Committee of Experts on the Transport of Dangerous Goods and on the Globally Harmonized System of Classification and Labelling of Chemicals

UN 38.3 Lithium battery testing and amendments to the T.5 external short circuit test

Transmitted by PRBA – The Rechargeable Battery Association*, **

Example of plot illustrating metal case temperature vs. internal cell temperature

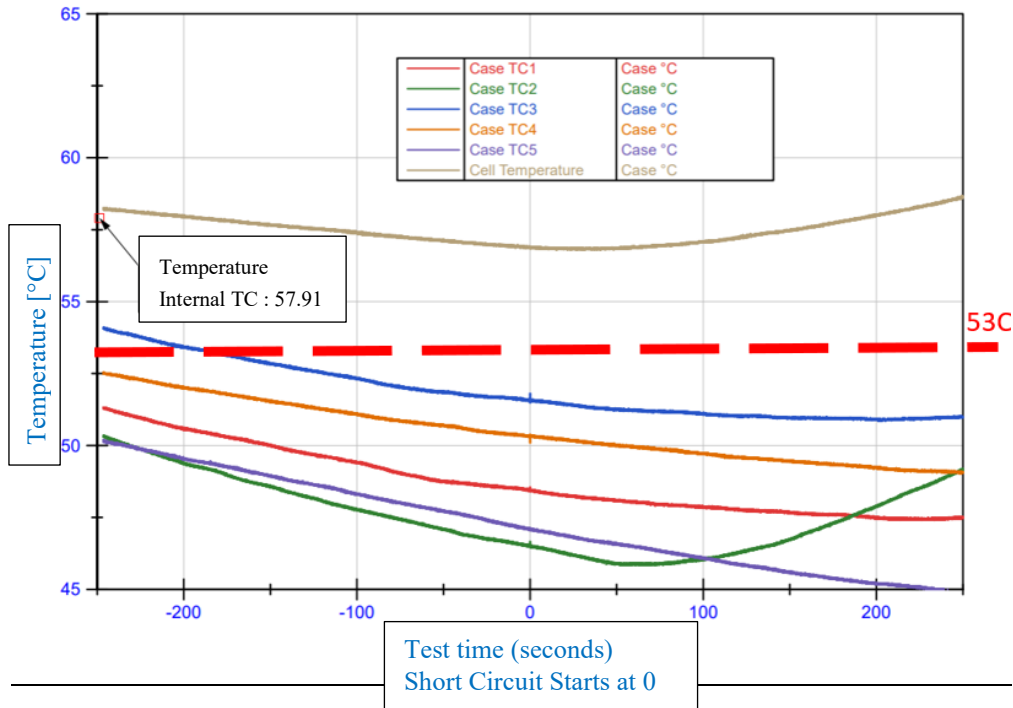
rapidly as it equilibrates with ambient lab temperature. However, the internal cell temperature is rather stable during this test setup period (reference Figure).

5. The internal cell temperature is the critical temperature for performing the short circuit test faithfully. It is believed that as long as the cell temperature is 57 ± 4 °C the intent of the test is met.
6. PRBA therefore proposes a change to the text of the T.5 test procedure to clarify the temperature measuring point.

“The cell or battery to be tested shall be heated for a period of time necessary to reach a homogeneous stabilized temperature of 57 ± 4 °C, measured on external case or an internal cell. This period of time depends on the size and design of the cell or battery and should be assessed and documented. If this assessment is not feasible, the exposure time shall be at least 6 hours for small cells and small batteries, and 12 hours for large cells and large batteries. Then the cell or battery at 57 ± 4 °C shall be subjected to one short circuit condition with a total external resistance of less than 0.1 ohm.

This short circuit condition is continued for at least one hour after the cell or battery ~~external case~~ temperature has returned to 57 ± 4 °C, or in the case of the large batteries, has decreased by half of the maximum temperature increase observed during the test and remains below that value.”
